# EMERGENCY ALERT SERVICE BULLETIN

**FIRE PROTECTION - Engine fire detectors**  
**Check and replacement of the engine fire detectors**

HELICOPTER CONCERNED	NUMBER	Version(s)	
		Civil	Military
AS365	26.00.12	N3	K2
AS565	26.00.08		MB, SB, UB
SA366	26.02		GA
EC155	26A009	B, B1

Revision No.	Date of issue
Revision 0	2022-12-19

#### 2.5. Block diagram for this SB

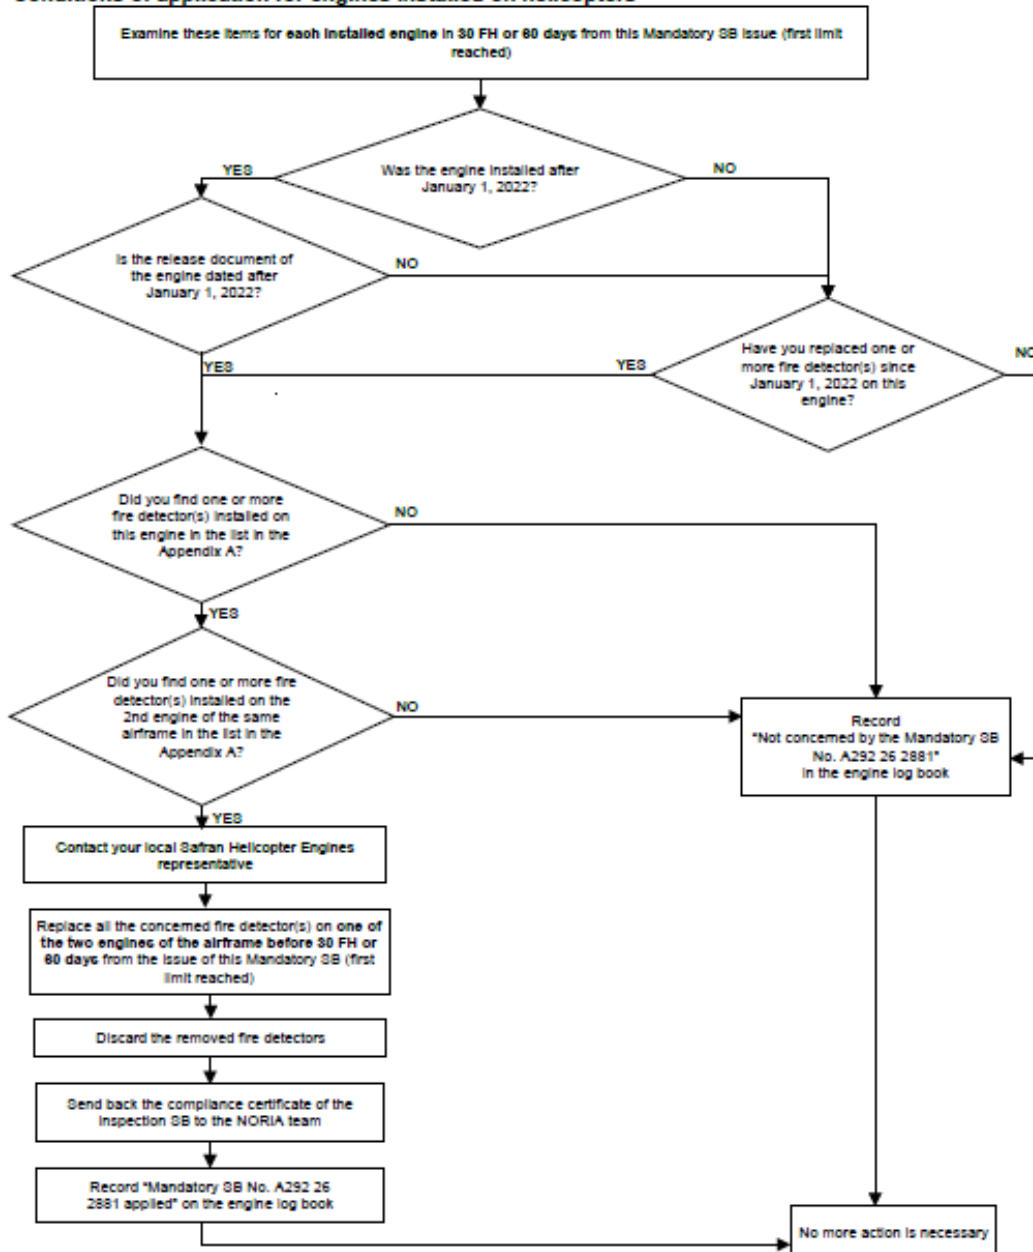
- Do a check of the airframes to know if they have two engines with one or more fire detectors given in the list in the Appendix A.
- Replace the concerned fire detectors on one engine of the airframe, if the two engines of the airframe have one or more fire detectors given in the list in the Appendix A.
- Discard the concerned fire detectors.
